## **Technical Bulletin / Safety Alert**

**Unique ID No:** TBS2011-TBSA-02

**Subject:** VLI Drifrunner Transport Braking System – Service Brake Diaphragm

**Applicable to:** Design Registered Transport Braking Systems  
(MDR 083991 TBS, MDR 083991 TBS-1 & MDR 096013 TBS)

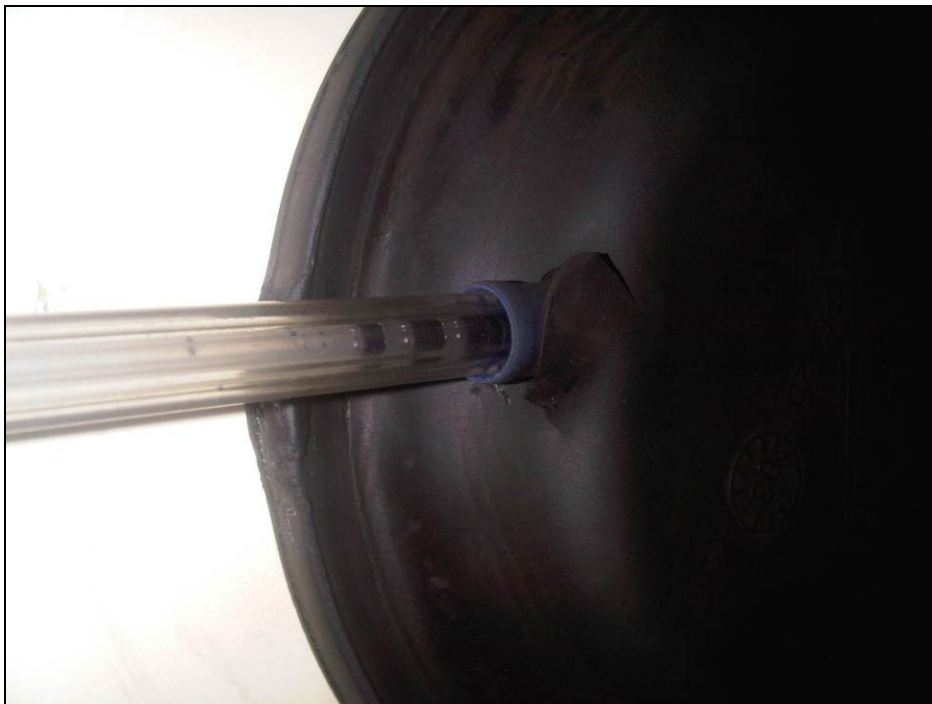
The following images show the service brake diaphragm after removal from the machine, with the hole highlighted.

Based on the age of the machine, the estimated diaphragm component life was 8 years. This was the first known occurrence of a diaphragm failure on a VLIDD machine. Based on the information and evidence received, it was not possible to identify the root cause of the diaphragm failure.

Based on the transport braking system design FMEA review and re-ranking of the diaphragm component, following this failure, VLIDD is recommending that service brake diaphragm components are replaced every 5 years.
